**Re: Review of Strada Aggregates Shelburne Pit: Proposed 2010 Groundwater Monitoring Program, Whitewater Hydrogeology Ltd. Letters dated August 6 and August 16, 2010**

**Re: Review of Strada Aggregates Proposed Melancthon Pit Level 2 Hydrogeological Assessment, Whitewater Hydrogeology Ltd. Letter dated August 16, 2010**

**Re: Strada Aggregates: Resolution of Monitoring Programs**

**Re: Strada Aggregates: Proposed Melancthon Pit Level 2 Hydrogeological Assessment  
Response to the Township of Melancthon's Peer Review Comments (Response #2)**

**Figure 1**  
**Groundwater**  
**Monitoring Program**

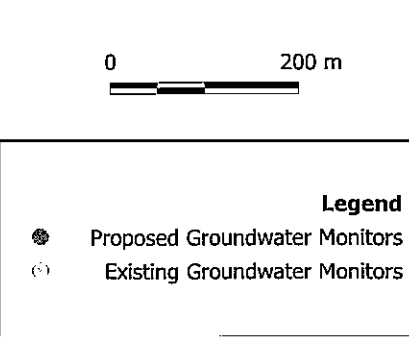
The August 16, 2010 letter provides for the installation of additional groundwater monitors at three (3) locations, described as MW-8, MW-9 and MW-10. Details of what we deem to be required at each location are provided below:

MW-8 – Wells currently installed at this location (MW3-04A and MW3-04 B) are consistently dry. Although MW3-04A does not extend the full depth of the overburden at this location, the lack of a measurable water level within the upper portions of the bedrock aquifer at MW3-04B would support the contention that the overburden is dry at this location. Based on this information, MW-8 should be installed within the bedrock aquifer and should provide a screened section that adequately monitors the top of groundwater and allows for variations of the groundwater level over time (making it available for sampling each year). This new well should be added to the yearly monitoring including groundwater elevation determination and sampling for current parameter list.

MW-9 – The existing shallow well (MW2-04A) does not extend the full depth of the overburden at this location. Groundwater elevations (max 483.5 m in 2009) determined for the deep well (MW2-04B) suggests that groundwater may be present in the area just above the bedrock (at least at certain times of the year). Based on this information, the additional wells should include a shallow well (MW-9A) effectively installed to the top of bedrock elevation and a deep well (MW-9B) that effectively monitors the top of groundwater within the bedrock aquifer (current deep well is screened well below this level). Both wells should be added to the monitoring/sampling program.

MW-10 – The current shallow wells installed at this location (MW-5A, MW7-07A and MW7-07B) do not adequately monitor for PHC impacts. MW-5A does not extend the full depth of overburden and is consistently dry. MW7-07A is too shallow and does not intercept groundwater. MW7-07B extends the full depth of overburden, intercepts shallow groundwater but the screened section of the well is too far below the top of groundwater to effectively monitor for PHC impacts. MW5-04B is installed within the shallow part of the bedrock aquifer. Although the measured groundwater levels at MW5-04B do rise above the screened section of the well, they appear to frequently lie near the contact of overburden and bedrock. Based on this condition, we feel that MW5-04B can be utilized as on-going bedrock monitor. Based on this information, the proposed additional well should consist of a well that can effectively monitor shallow groundwater within the overburden. Both this additional well and MW5-04B should be included in the on-going monitoring.

With the understanding that the current groundwater monitoring program complies with the site regulations, the Township was able to clearly explain that they have additional concerns that are not currently covered by the regulatory requirements. In order to satisfy the Township that the site is effectively monitored, it was recommended that three additional wells be drilled and constructed to allow for the detection of petroleum hydrocarbons, if present. These wells would be added to the current compliance monitoring program. The locations of the proposed groundwater monitoring wells are provided on Figure 1.

Strada agreed to the recommended changes at the August 11<sup>th</sup> meeting and Whitewater has been given permission to proceed with the work program, once final approval from the Township has been given writing. The new wells will be drilled and constructed to meet the Townships requirements in 2010 and will be added to the compliance groundwater quality sampling program in the spring of 2011. It should be noted that the compliance monitoring for 2010 has been completed and no detections of hydrocarbons were reported.
